NORTH SYDNEY COUNCIL REPORTS

NSLPP MEETING HELD ON 15/06/2022 SECTION 4.55 APPLICATION – SUPPLEMENTARY REPORT

ADDRESS/WARD: 182 Kurraba Road, Kurraba Point

APPLICATION No: DA 333/19/4

Figure 1 – Excerpt of Section A- A drawing No DA_300_00 (Daniel Younan & Assoc)

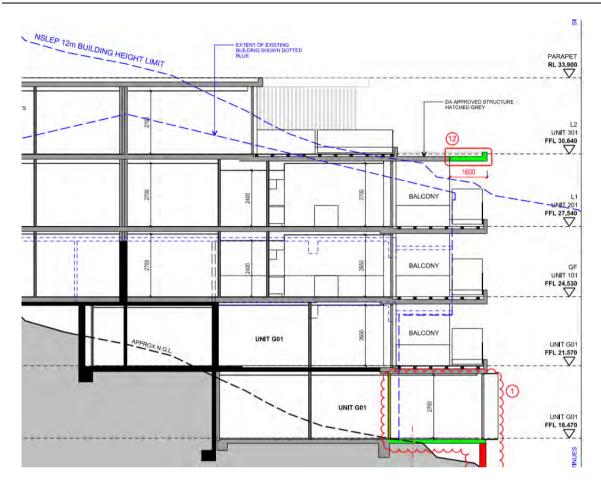
The additional breach can be seen in Figure 1 below and its only purpose is the provide better weather protection for the unit below. The top of the roof or deck is non trafficable.

As no significant impacts will occur as a result of the roof projection, the minor variation would not be inconsistent with the objectives of the standard in terms of compatibility with the local area character, not significantly affecting bulk and scale, and improving amenity for the residents.

Figure 2 - 10m & 3.8m wall highligted yellow on stamped plans for s.4.55 DA 333/19/2 issued 9.6/2021.

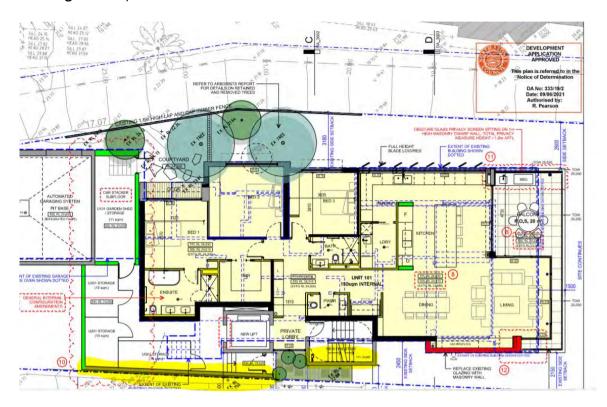
9) Concern to non-compliant setbacks, 'new' 10m wall on the southern boundary, 'new' 3.8m long wall (fire stairs) setback 900mm to southern boundary.

Comment: The 'new' 10m wall on the southern boundary and shorter 3.8m wall to the fire stairs were approved in the original DA 333/19 consent and s.4.55 modification. (See **Fig 2** below).

Both of the walls highlighted in **Figure 2** have been previously approved and not the subject of this current s4.55 modification.
